DEVELOPMENT DETERMINATION PANEL MEETING

WEDNESDAY 27 NOVEMBER 2019

**MOD2019/0409 - 2 TOURMALINE STREET, NARRABEEN -
MODIFICATION OF DEVELOPMENT CONSENT DA2018/1290
GRANTED FOR ALTERATIONS AND ADDITIONS TO AN
EXISTING DWELLING HOUSE**

APPLICATION FOR MODIFICATION ASSESSMENT REPORT

Diagram 1. Modified southern elevation with modified window changes

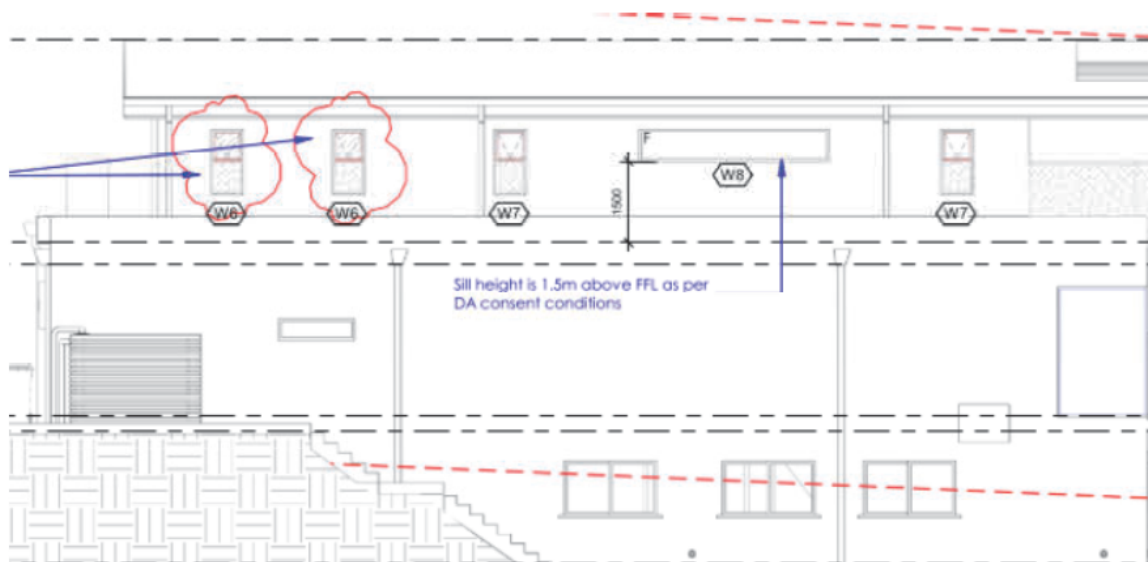
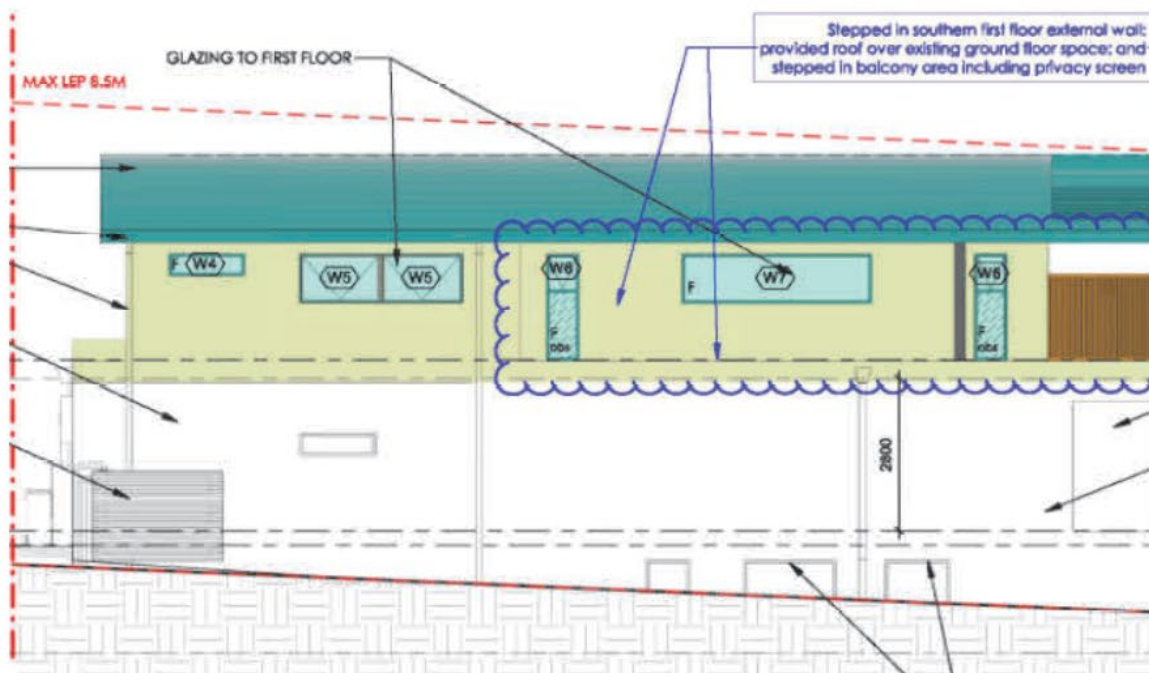
The changes to the southern elevation windows will have direct impact to the amenity of the adjoining property to the south, being No.171 Ocean Street, Narrabeen.

The modified windows are shown as shaded on the submitted plans to represent opaque glazing. However, as this is not documented on the submitted plans, and in absence of a window schedule, a condition is included to ensure that these shaded areas of windows are treated with opaque glazing. This will ensure a reasonable level of privacy and amenity to No.171 Ocean Street Narrabeen is achieved, and also demonstrates consistency with the DDP condition.

- a) Windows W6, adjoining the en-suite on the southern elevation are to be fitted with obscure glazing.
- b) Window W7 adjoining the stairwell on the southern elevation is to be fitted with obscure glazing to a minimum height of 1.5m above the finished floor level.
- c) Window W7 adjoining the sitting room on the southern elevation is to be fitted with obscured glazing to a minimum height of 1.5m above the finished floor level.
- c) The privacy screens adjoining the balconies on the southern elevation are to be fitted with obscure glazing.
- d) The roof is not to encroach above the road reserve on Pacific Lane, and is to remain wholly within the property boundaries.
